**IN THE DRAWINGS**

FIGURE 4

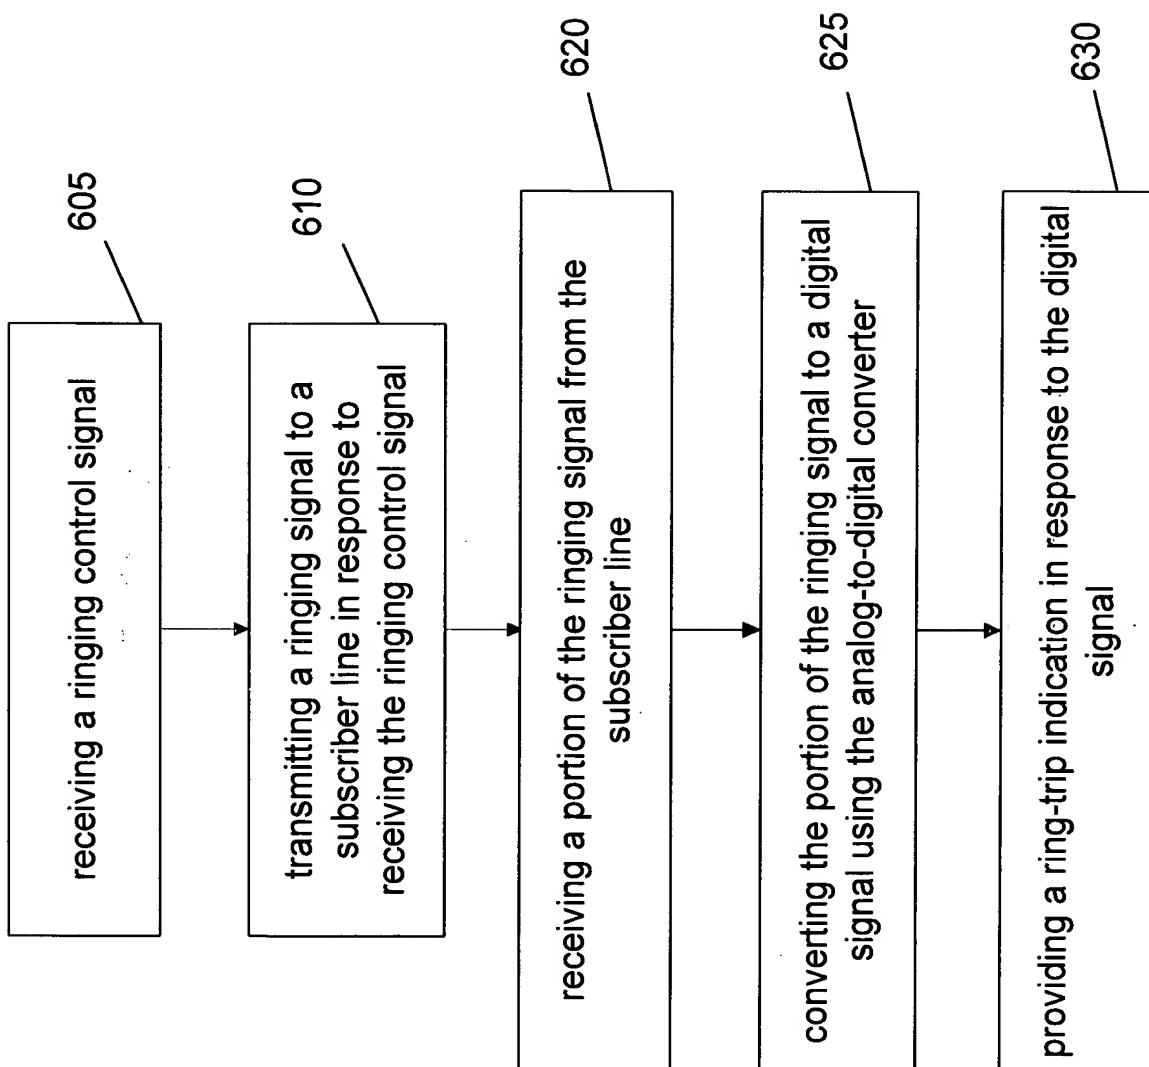
Figure 4 of the drawings has been amended to amend box 625 to correctly reflect "converting the portion of the ringing signal to a digital signal using the ~~digital-to-analog~~ analog-to-digital converter." Figures 1-4 have been resubmitted.
